7.0 TRAIL ALIGNMENT CHANGES IN RESPONSE TO COMMENTS

7.1 Area 1 – Peery Camp

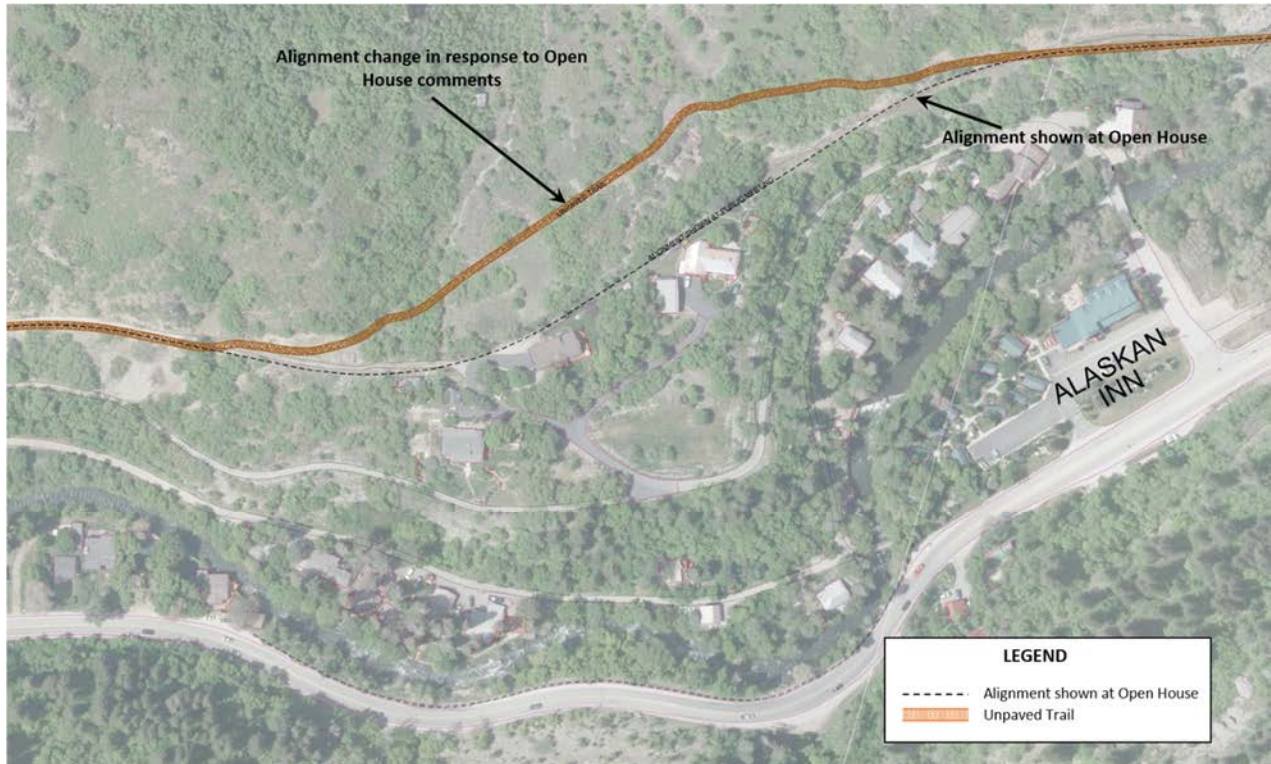
The biggest trail alignment changes based on public comment were made around the Peery Camp area. There was a lot of concern about how close the proposed trail was the homes in Peery Camp. To mitigate these concerns, the trail was moved up the mountainside to the north to respect the privacy of the Peery Camp residents. A maximum slope of 6% was used to gain elevation up the mountainside and to take the trail back down towards the river.

Another concern in the Peery Camp area was the proximity of the trail to the homes at the west end of Lower Fairmont. There were worries that trail users coming down the mountain from the pipeline could see into the homes by the lower switchback, and that they could even cause erosion or debris problems for the Lower Fairmont residents. To alleviate these concerns, the climb up the mountain was moved to the west, taking off from the adjusted alignment described above. The new proposed trail is designed with a 15% maximum slope. While not ideal, the 15% slope is not unprecedented – there are several places on the existing maintenance road for the pipeline where the slope is 15-20%. Also, this alignment requires another switchback. This option may mean putting in a wall or finding other ways to stabilize the slopes along the trail, but at this point it seems feasible.

7.3 Area 3 – East of Gray Cliff Lodge

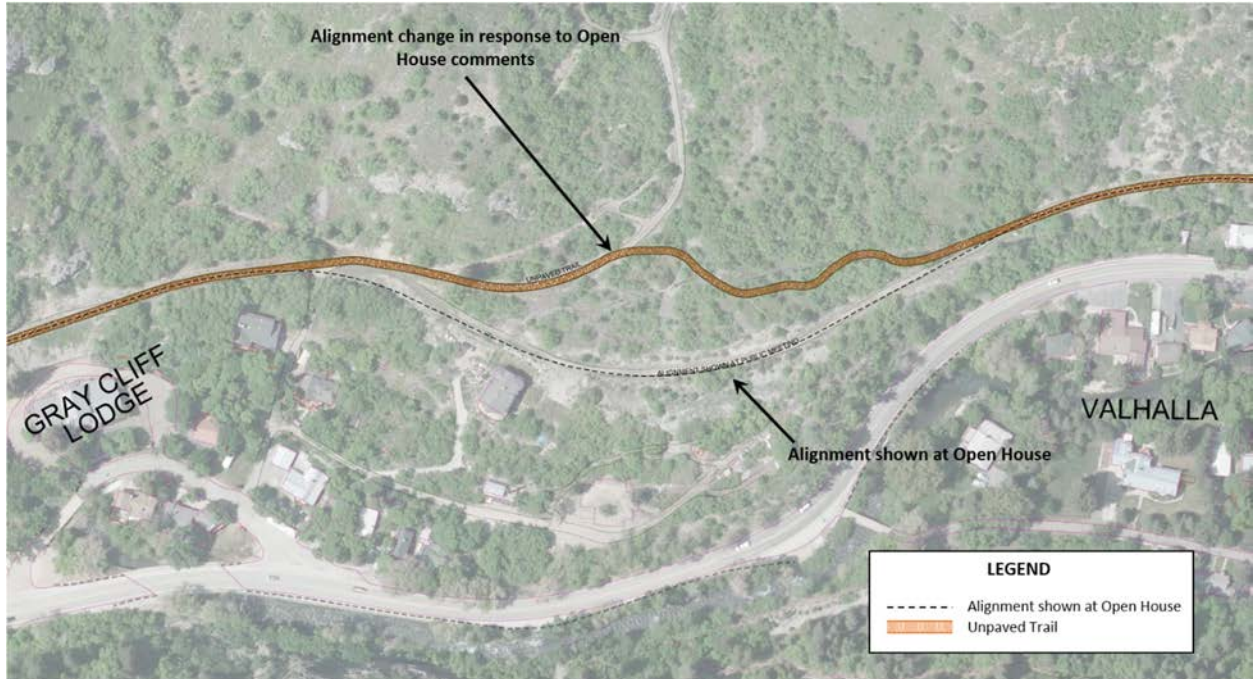
This area is very similar to the Alaskan Inn area – the trail was moved slightly uphill to avoid close proximity to homes.
